Reliability Analysis Update

Transmission Expansion Advisory
Committee
April 1, 2025

Scope Change & Cost Updates Baseline Reliability Projects

Scope change for B3800.210 – B3800.212 (230kV Line Mars – Lockridge – Golden & 500kV Line Mars – Golden)

New Mars – Lockridge – Golden 230kV Lines

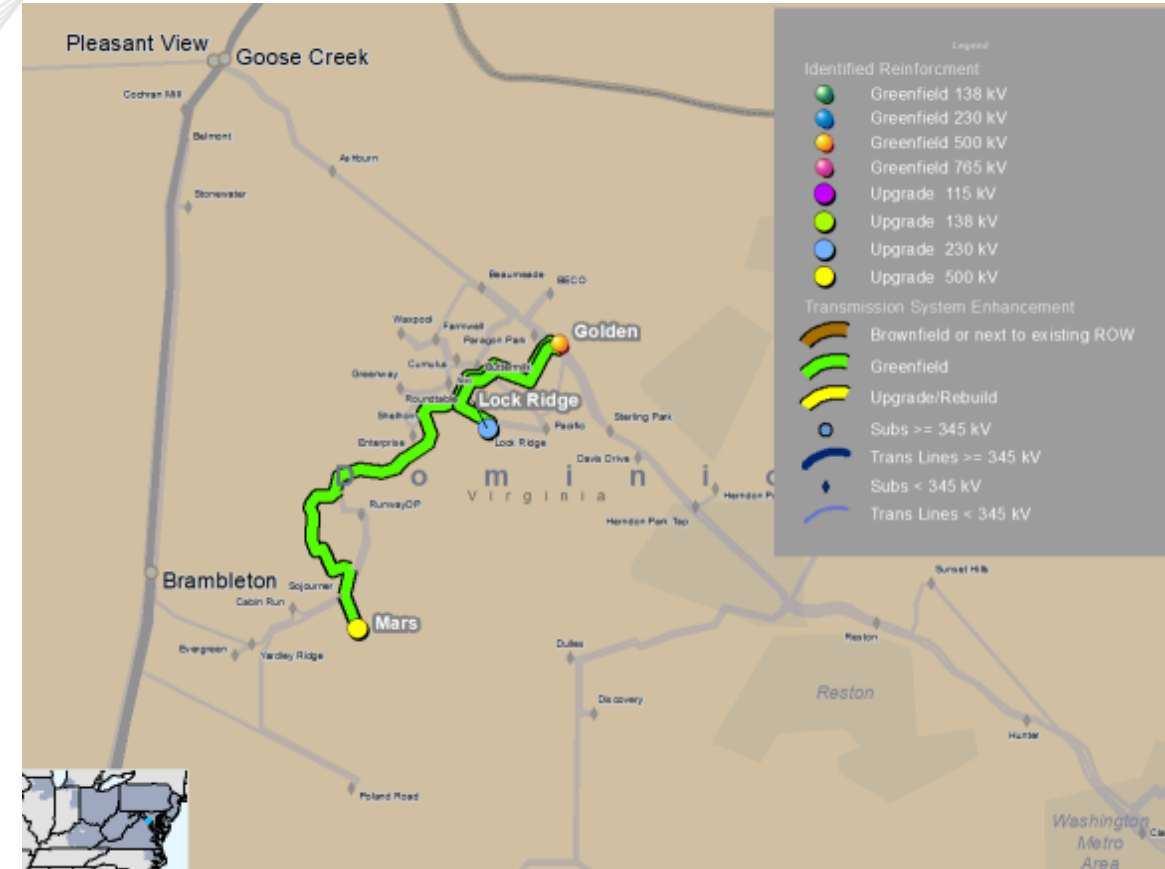
Part of the recommended solution for 2022 Window 3 (2022-W3-692) is to construct a new 230kV line from Mars – Lockridge – Golden and a new 500kV line from Mars – Golden.

- Build a new 230kV line approximately 5.2 miles from Mars - Lockridge on 500/230kV double circuit structures to achieve a summer rating of 1573 MVA. Install 230kV equipment at Mars and Lockridge substations. **(B3800.210) \$57.95M**
- Build a new 230kV line approximately 2.9 miles from Lockridge - Golden on 500/230kV double circuit structures to achieve a summer rating of 1573 MVA. Install 230kV equipment at Golden and Lockridge substations. **(B3800.211) \$56.93M**
- Build a new 500kV line approximately 8.3 miles from Mars substation to Golden substation on 500/230kV double circuit structures to achieve a summer normal rating of 4357 MVA. Install 500kV equipment at Golden and Mars substations. **(B3800.212) \$228.04M**

Transmission Arrangement for area surrounding Mars before addition of Golden-Mars 5-2 project (after completion of Wishing Star – Mars project)

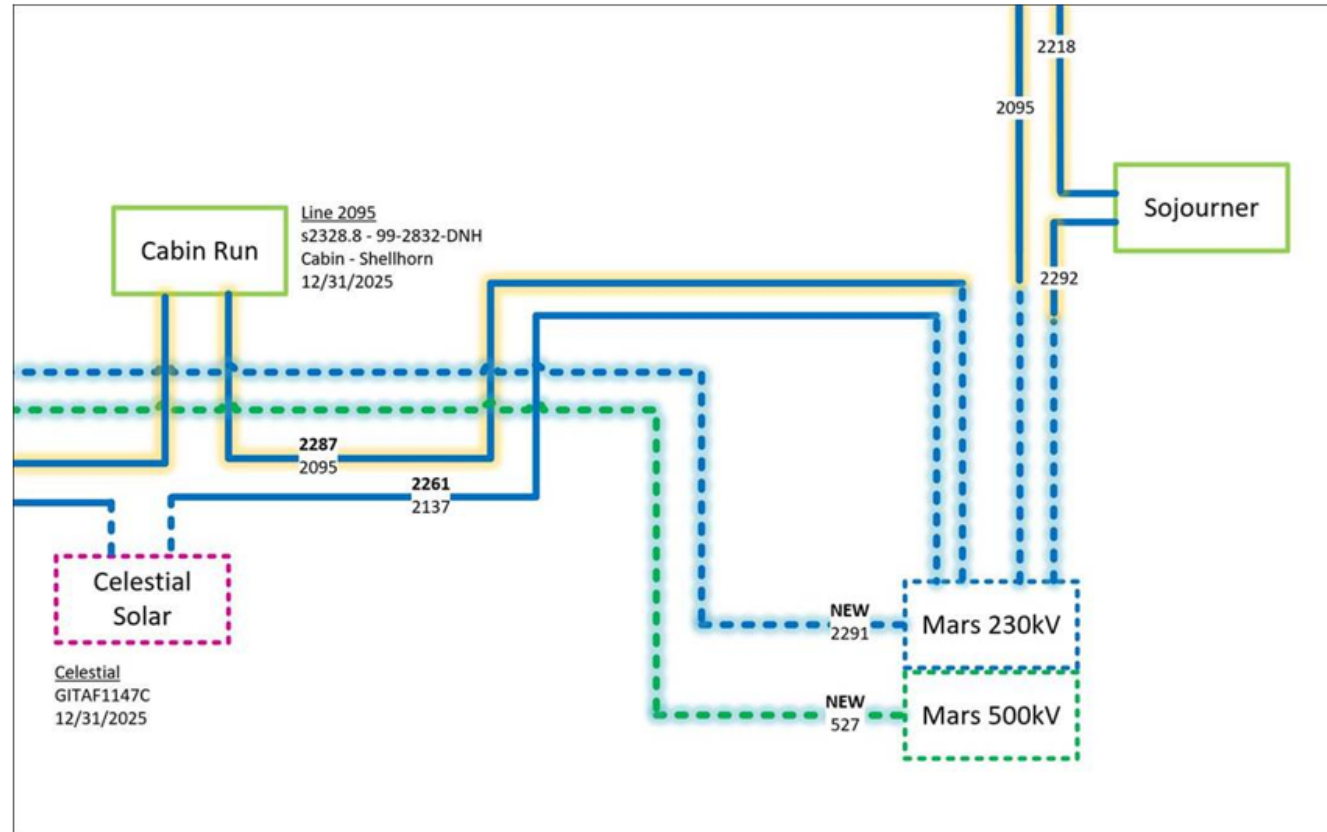
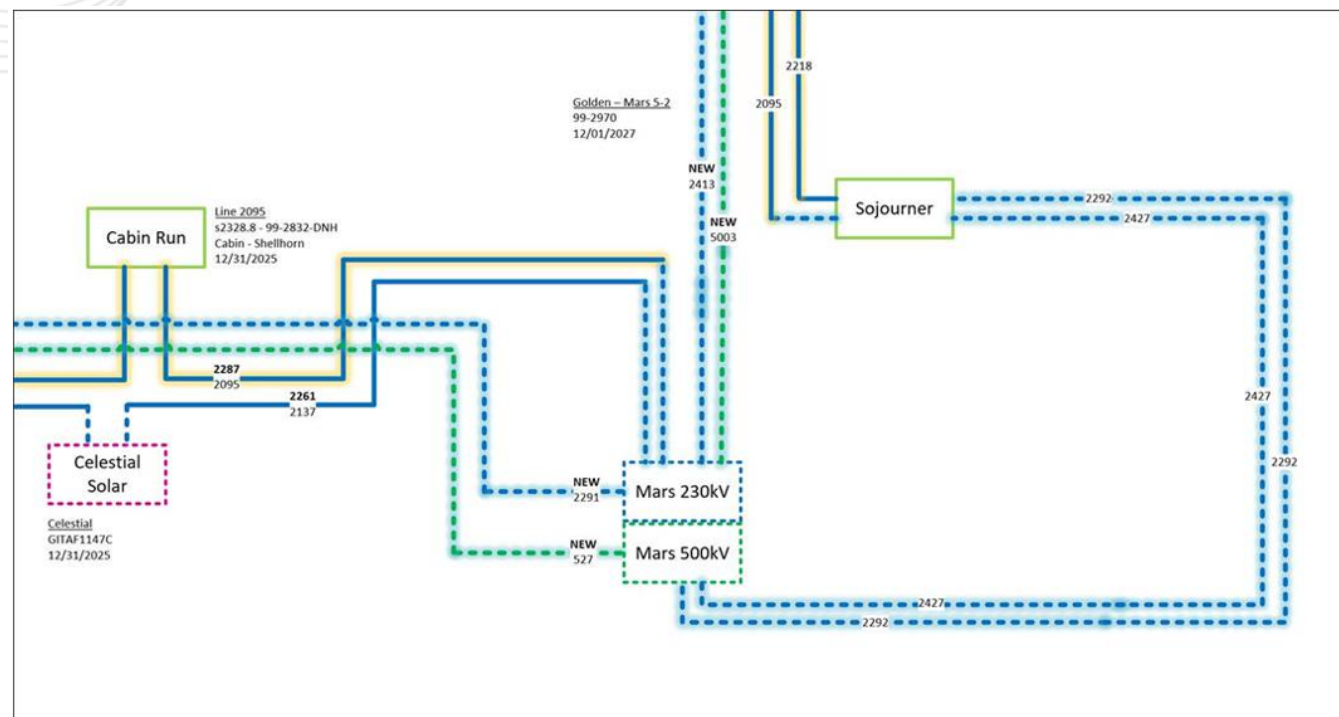
Reason for Scope Change & Cost Update:

- The new Golden – Mars 230kV & 500kV lines will intersect with the existing transmission corridor containing the 230kV lines Mars-Shellhorn Line #2095, Mars-Sojourner Line #2292, Celestial-Mars Line #2161, and Cabin Run-Mars Line #2287 just east of the Old Ox/Carters School Road Intersection. Spatial and FAA constraints along these existing lines would prevent installation of the Golden – Mars lines along any of the alternative routes.
- Cost increase due to additional 2 miles of transmission line and real estate required to reroute line #2095 Mars – Shellhorn & line #2292 Mars – Sojourner.

Revised Solution:

- Remove 230kV line #2095 Mars - Shellhorn and 230kV line #2292 Mars – Sojourner in the existing transmission corridor between Sojourner and Mars substations so that they can be re-routed to the south side of Mars substation, adding approximately 2 miles of new conductor. This is to allow for termination of the 5-2 Golden – Mars circuits into Mars substation.
- Cut 230kV line #2095 Mars – Shellhorn into Sojourner substation, creating 230kV line #2427 (Mars - Sojourner) and 230kV line #2095 (Sojourner - Shellhorn).
- Upgrade 4 230kV breakers at Sojourner substation from 63kA to 80kA

Additional Cost Estimate: \$97M (B3800.210 \$49M + B3800.212 \$48M)

APS Transmission Zone: Baseline Doubs 500kV Breaker Replacement

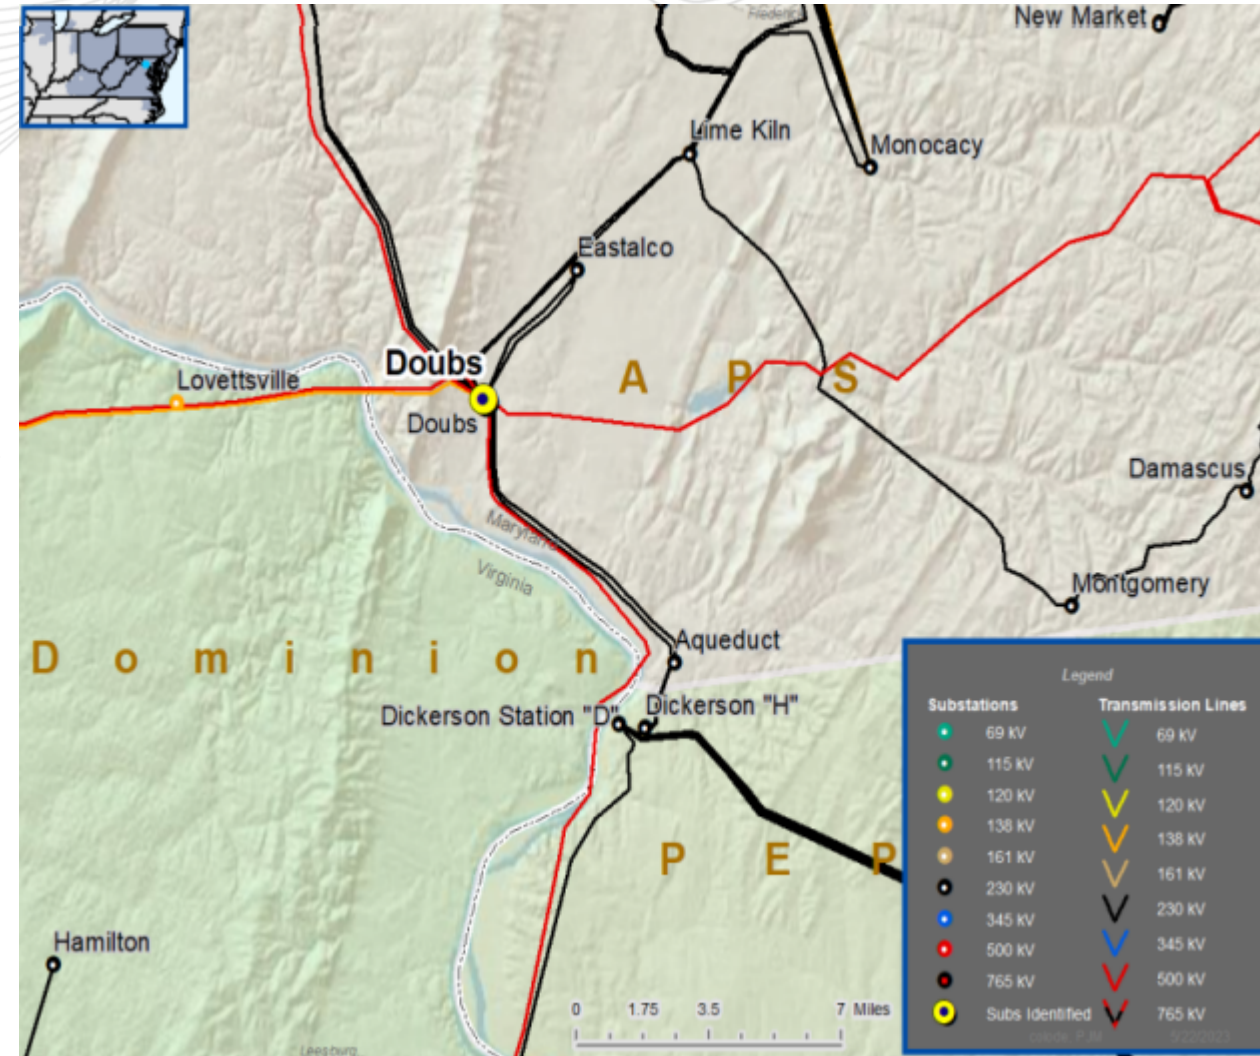
In the 2029 RTEP Short Circuit base case that includes the 2024W1 selected solution, 1-500kV breaker at Doubs substation was identified as being over duty.

Reason for Cost Change:

Original estimated cost incorrectly reflected the future “in-service year” installed cost rather than the current year cost.

Replace 50kA breaker DL-59 #2CAP with a 63kA breaker. **(b4000.110)**

Estimated Cost: ~~\$11.5 M~~ **\$10.06 M**

DOM Transmission Zone: Baseline Loudoun – Morrisville 500kV

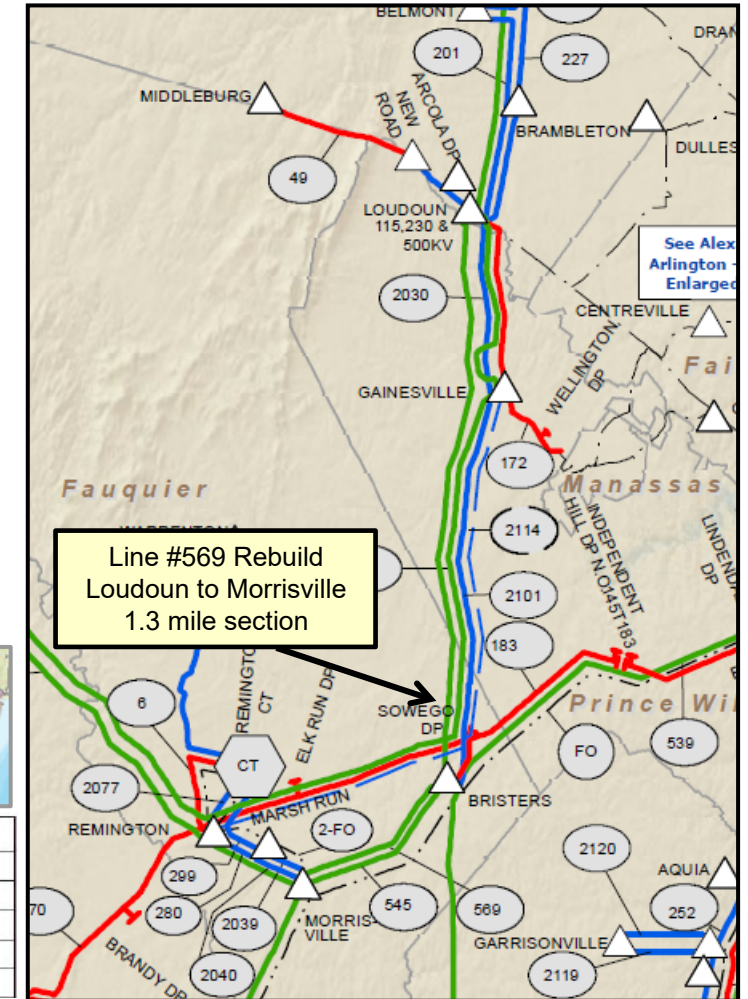
B3211: Rebuild the 1.3 mile section of Line #569 Loudoun to Morrisville with single-circuit 500 kV structures at the current 500 kV standard. This will increase the rating of Line #569 to 3424 MVA.

Cancellation Reason: Baseline project b3800.312 from 2022 Window 3 will rebuild entire portion of line #569 Loudoun – Morrisville, therefore eliminating the need project.

DOM Transmission Zone: Baseline Ox 500kV Breaker Replacements

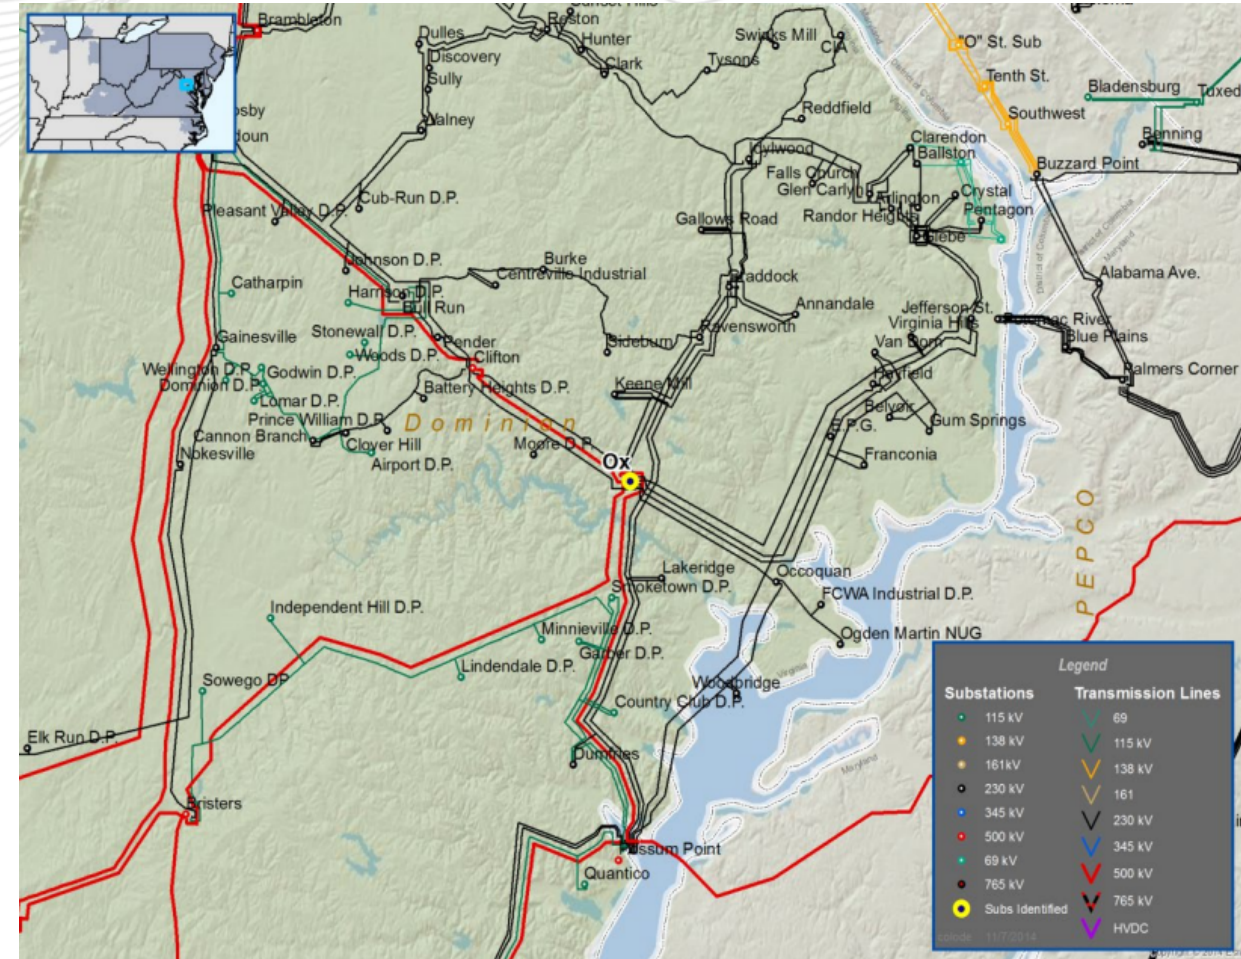
B4000.130: Replace 40kA breakers 56142, H1T539, H2T539 with 63kA breakers.

Baseline projects b3800.236 (H1T539, H2T539) & b3800.335 (56142) from 2022 Window 3 replace the same 3 breakers therefore eliminating the need for this project.
